**2009 D&R #4 Crude/DEBRU**

**PHA REVALIDATION REPORT**

## REVALIDATION OF THE D&R #4 CRUDE UNIT PROCESS HAZARDS ANALYSIS (PHA)

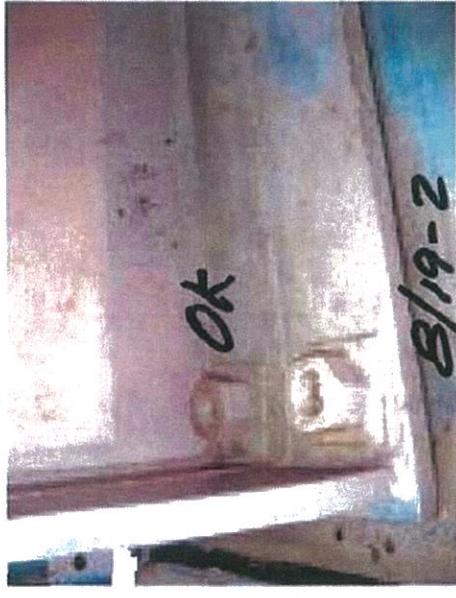
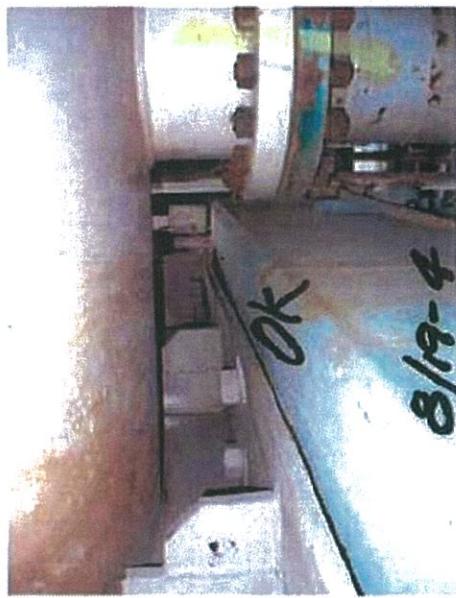
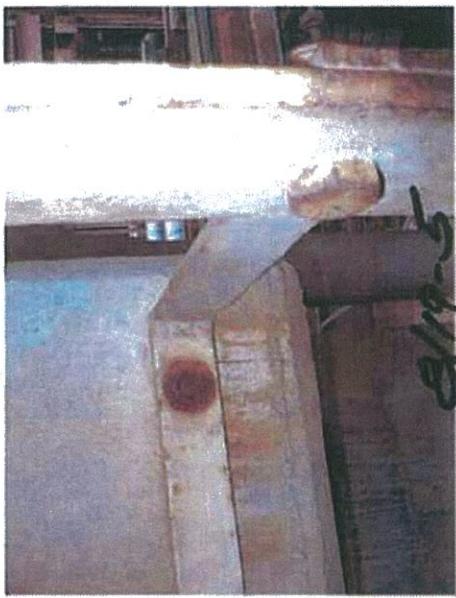
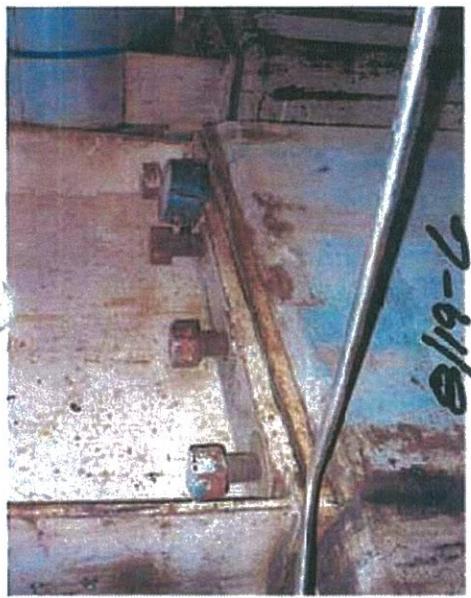
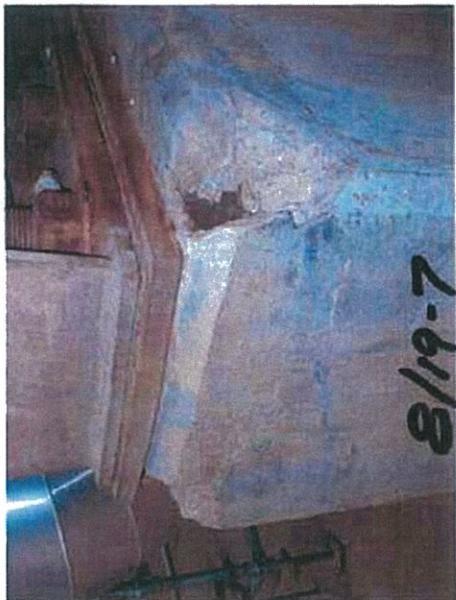
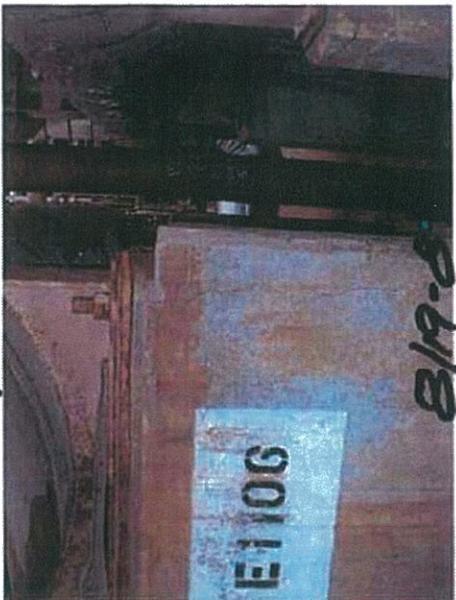
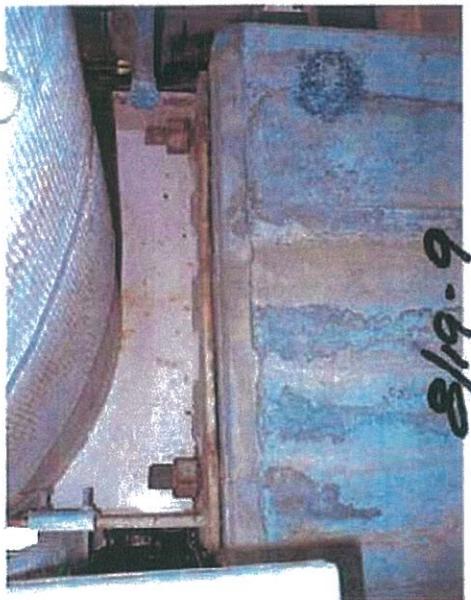
V1198 - inadequate nut/bolt engagement  
both ends PKS 22 & 23.
